Summary and Analysis of Comments to the Notice of Proposed Rulemaking:

"Evaporative Emission Regulation and Test Procedure for Gasoline-Fueled Heavy-Duty Vehicles"

April 30, 1980

Standards Development and Support Branch
Emission Control Technology Division
Office of Mobile Sources
Office of Air, Noise and Radiation
U.S. Environmental Protection Agency

Figure 1 Composite Distribution of Differential Daily Temperatures - 5 Cities (July & August)

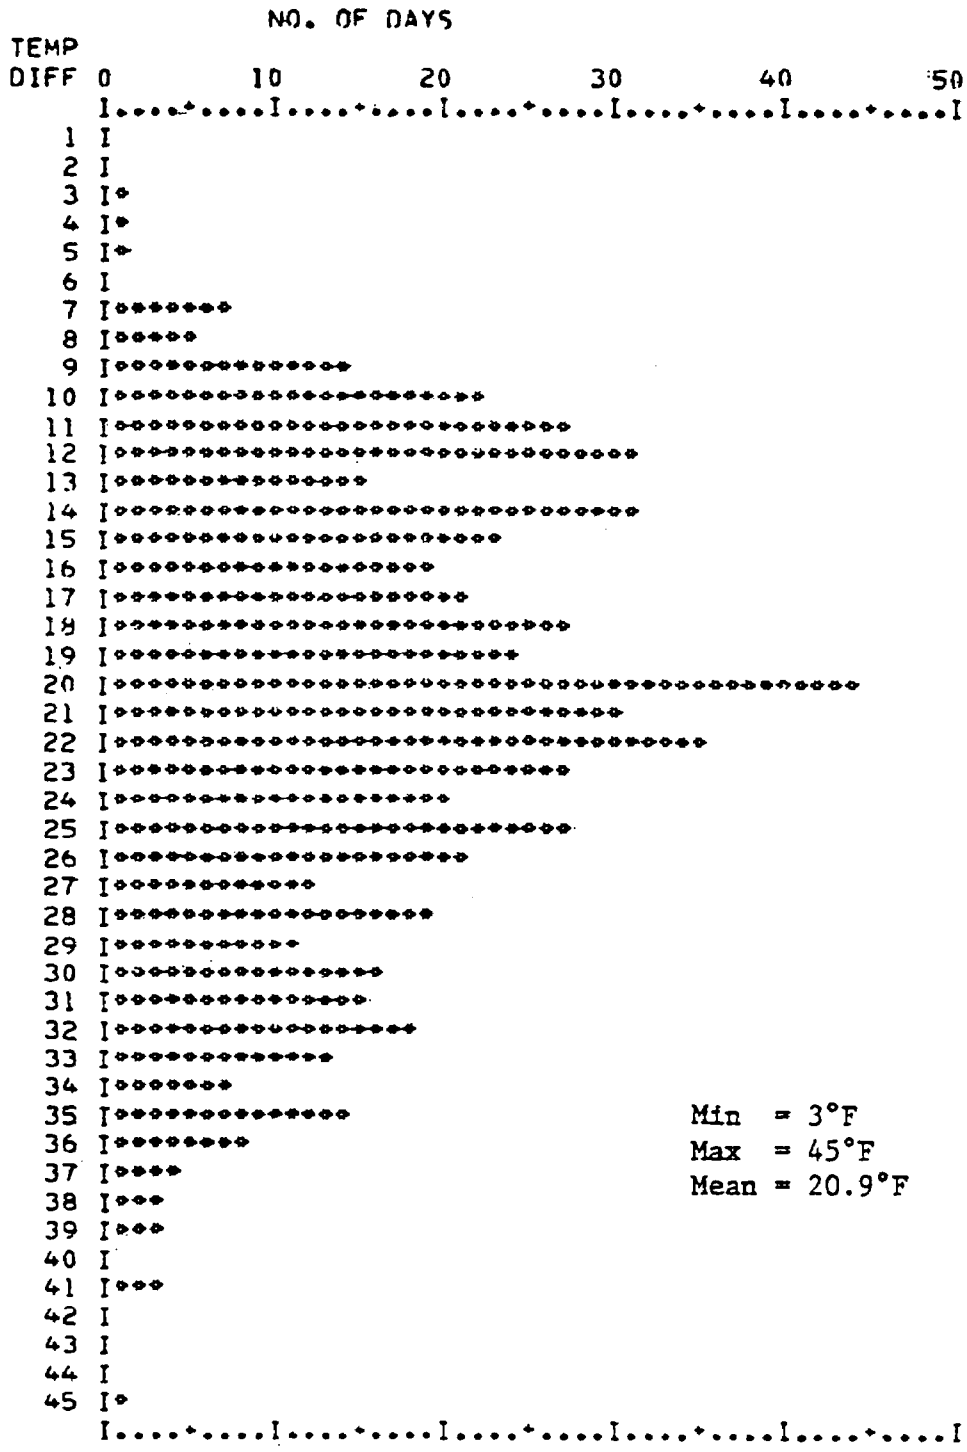
The typical summertime ambient temperature diurnal to which GM referred is exceeded many times. In fact, a 32°F ambient diurnal is not at all uncommon as Figure 1 indicates. A test procedure fuel temperature rise of 75 percent of such a 32°F ambient diurnal would yield 24°F. This is the fuel temperature rise of the proposed test procedure and we recommend its retention in the Final Rule.
